Frankfort Castle

Dundrum, Dublin 14

Statement of Response
June 2021

RESPONSE TO ISSUES RAISED BY ABP

2.1 Surface Parking Strategy

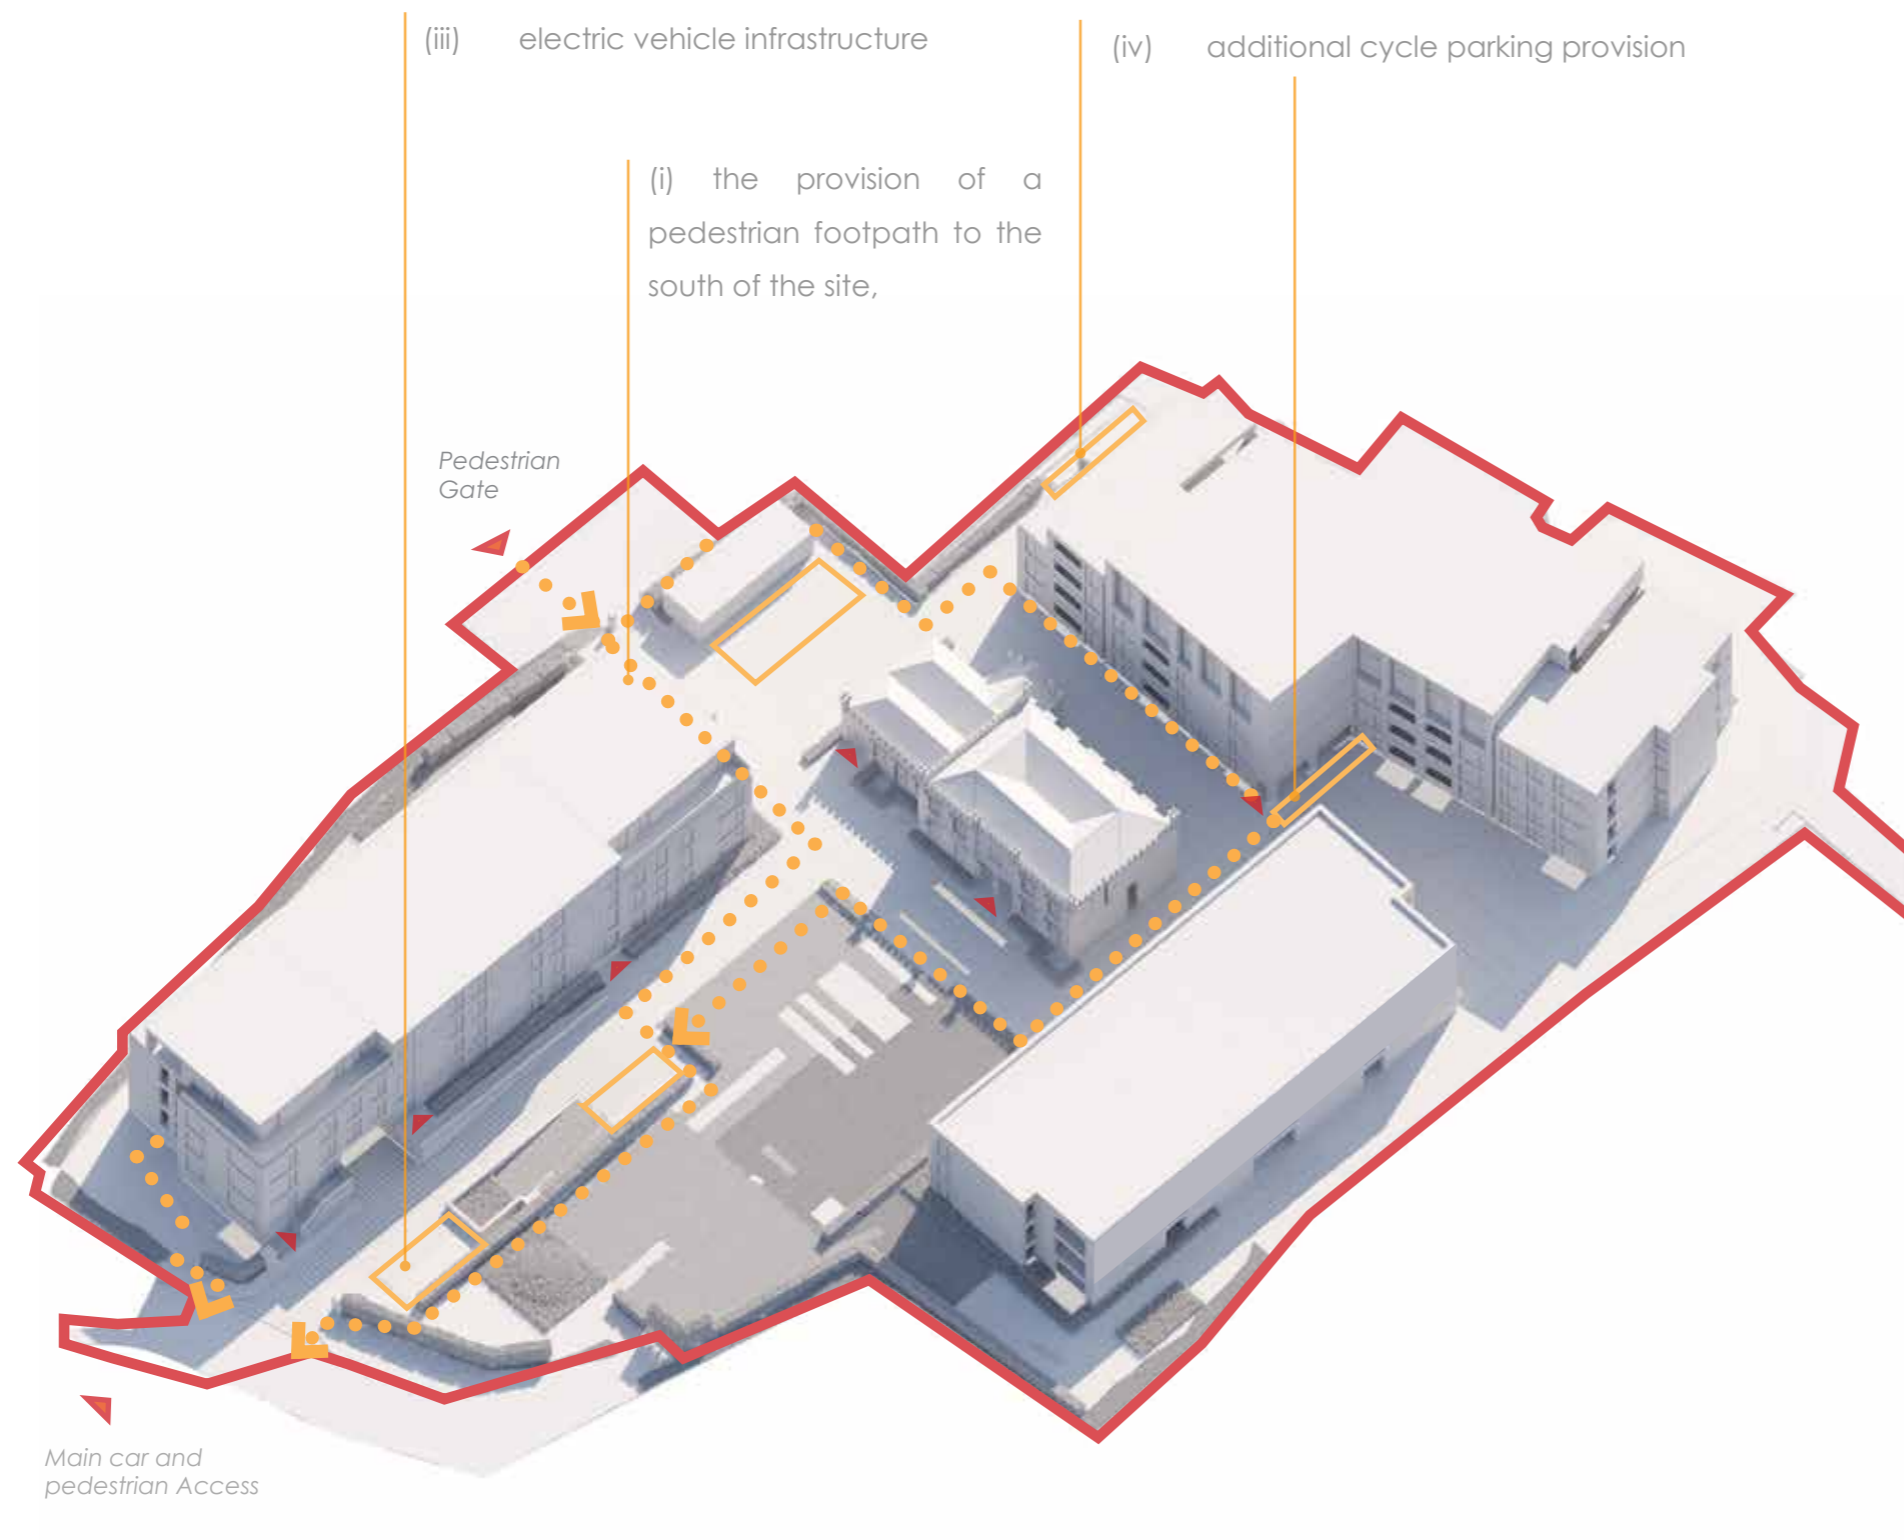
Planning rationale/justification as it relates to the level of car parking provision proposed, specifically noting the site's location close to public transport and that it is national policy to minimise reliance on the private car.

The carparking strategy has been developed to achieve 0.66 no. space per unit.

The surface carpark has been reconfigured and reduce in order to improve landscape amenity and treatment.

4. Childcare facilities

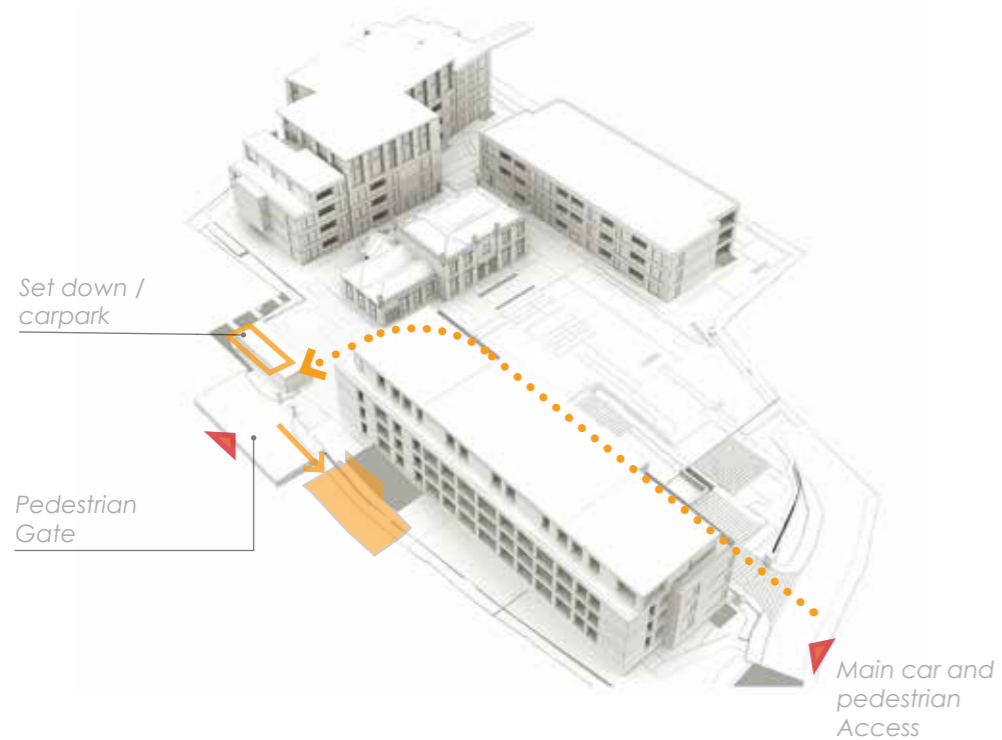
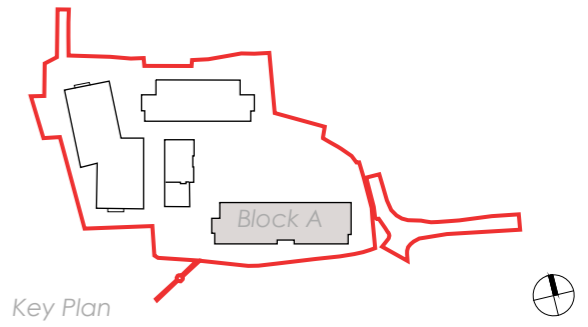
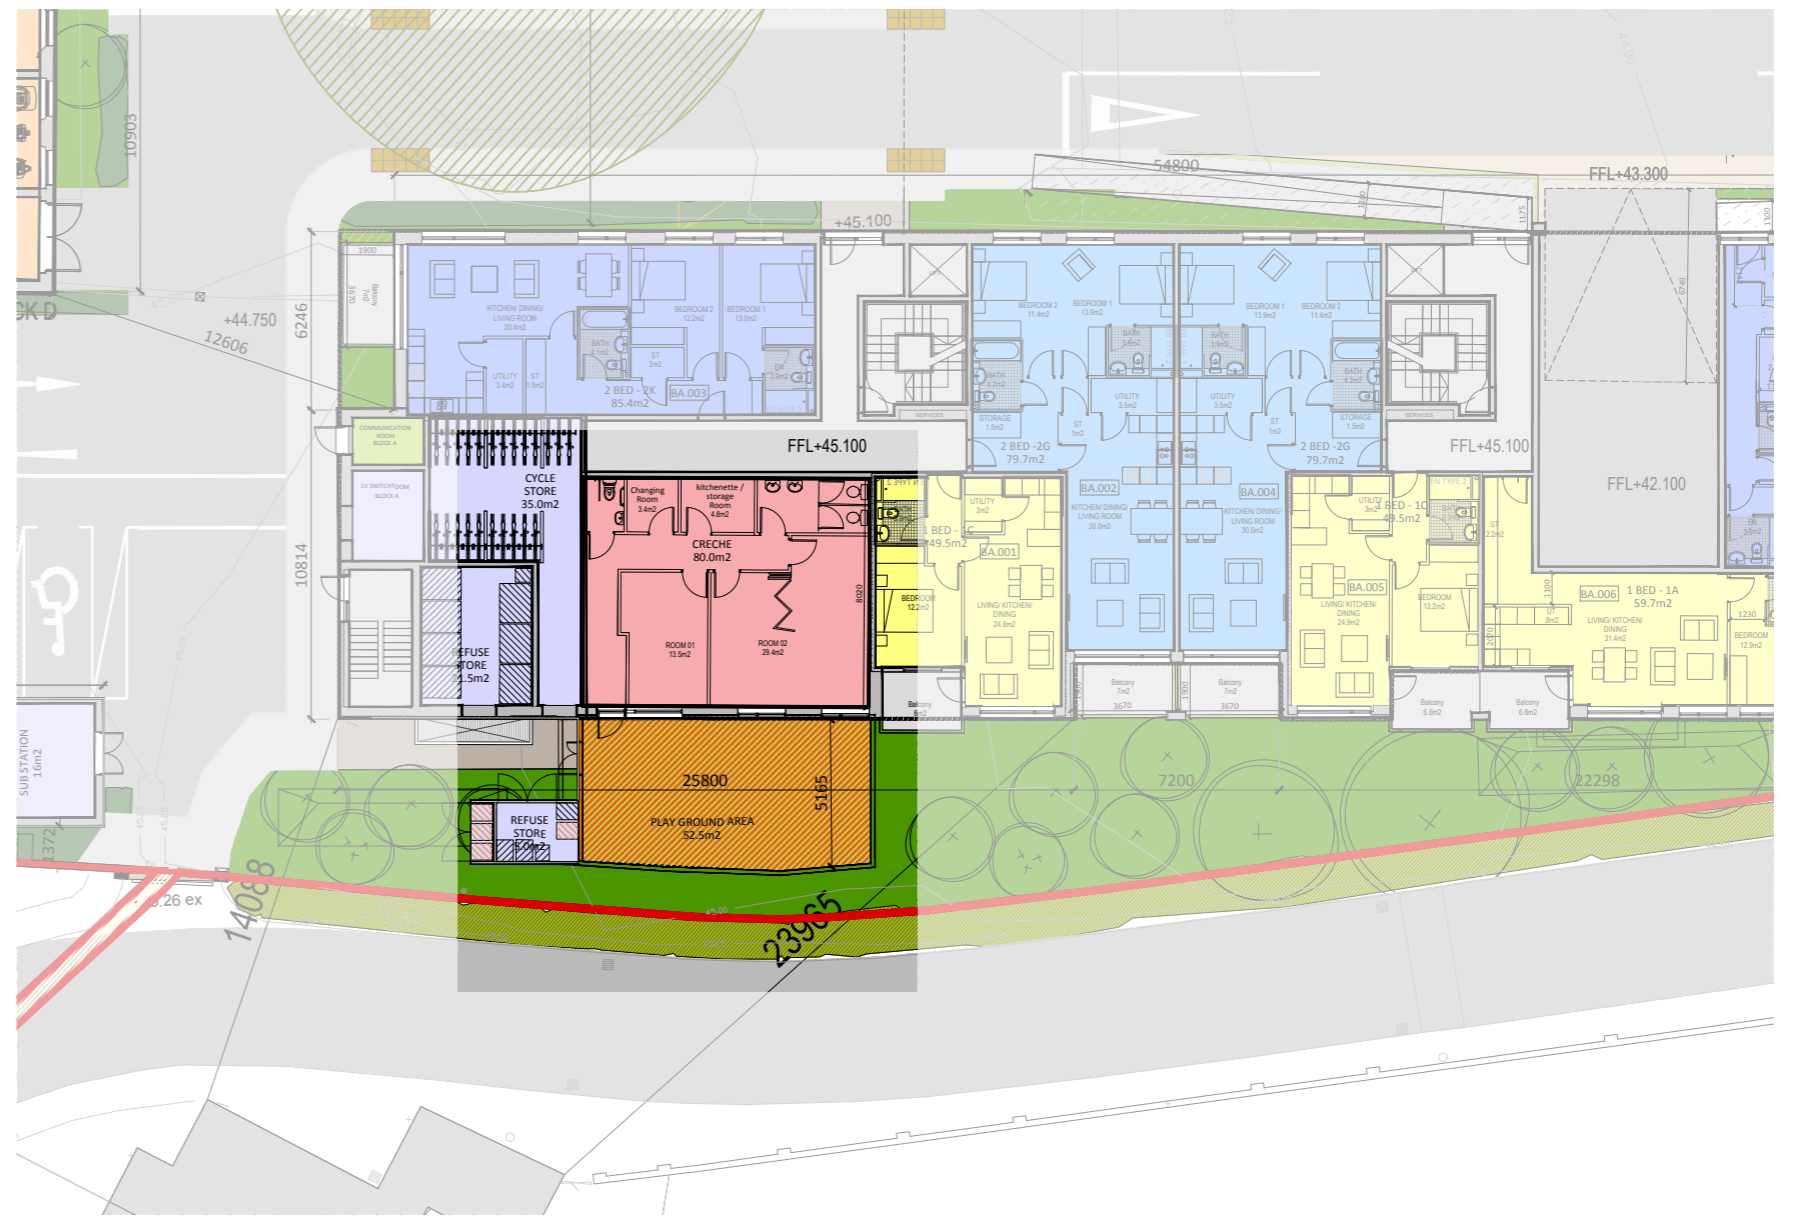
Rationale/ justification as to the provision of Childcare Facilities, or otherwise. Justification is required for the non-provision of childcare facilities, having regard to the criteria as set out in Childcare Facilities -Guidelines for Planning Authorities (2006).

Creche total area proposed for 20 children: 80sqm

Private Open Space: 52.5sqm

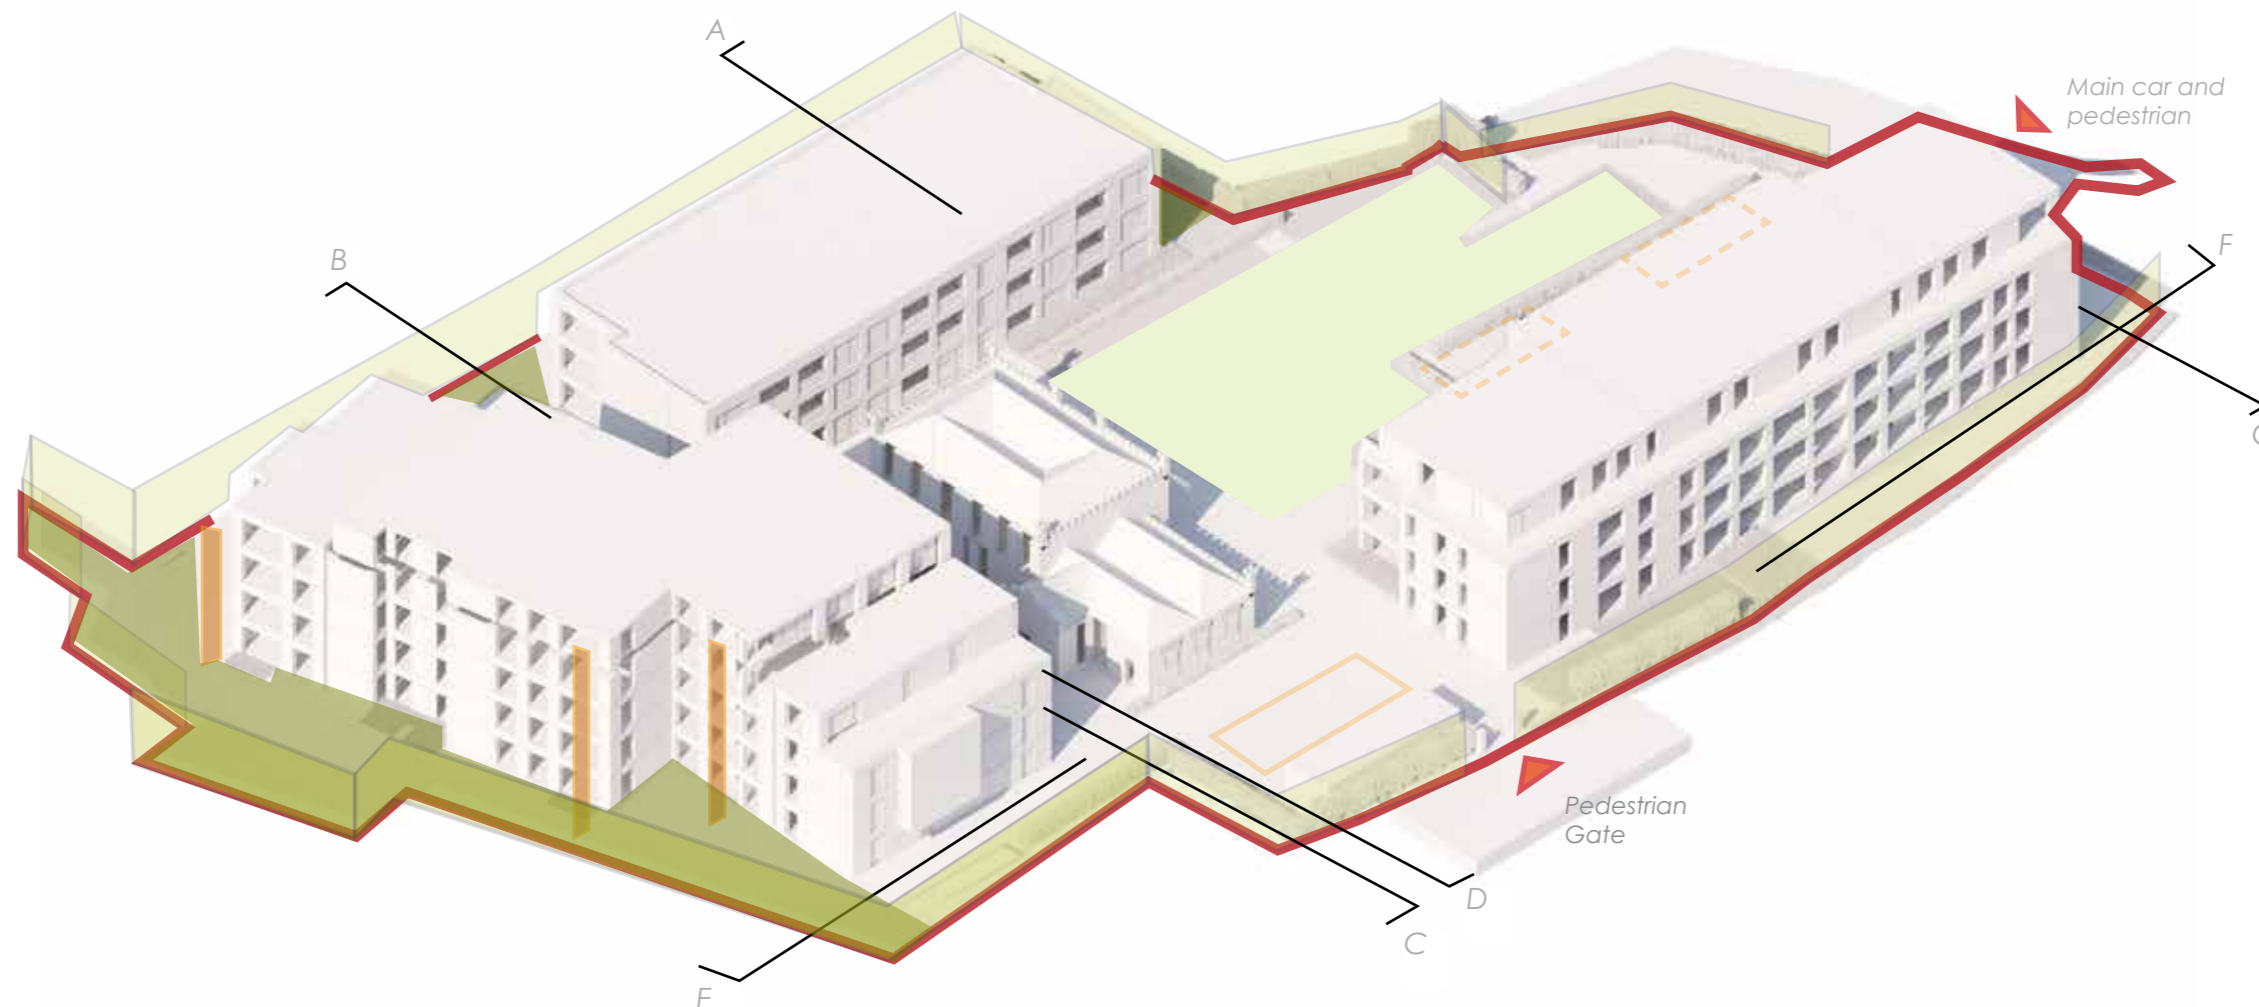
6. A plan of the proposed open space clearly delineating public, semi-private and private spaces should also be provided, as well as a detailed breakdown of the total area of same. These plans should clearly highlight how the proposals provide for an appropriate variety and suitable location(s) of children's play spaces.

Public open Space Required = 850sqm (10% of site area which is 8500sqm)
Public open Space Provided = 1000sqm (=12% of net Site Area)

Communal Open space Required = 979sqm
Communal Open space Provided = 1,025sqm provided in external landscaped communal open spaces (1) and (2).
 106.6 sqm of additional internal Residential amenity space is also provided in the retained Building D

Private Open Space (Balconies, Terraces) Required = 979sqm
Private open Space (Balconies, Terraces) Proposed = 1050sqm
 Provided in private balcony and terrace areas to each Apartment. Each Apartment is provided with a Private Amenity space with exception of 2 no. units at first floor to retained Building D.
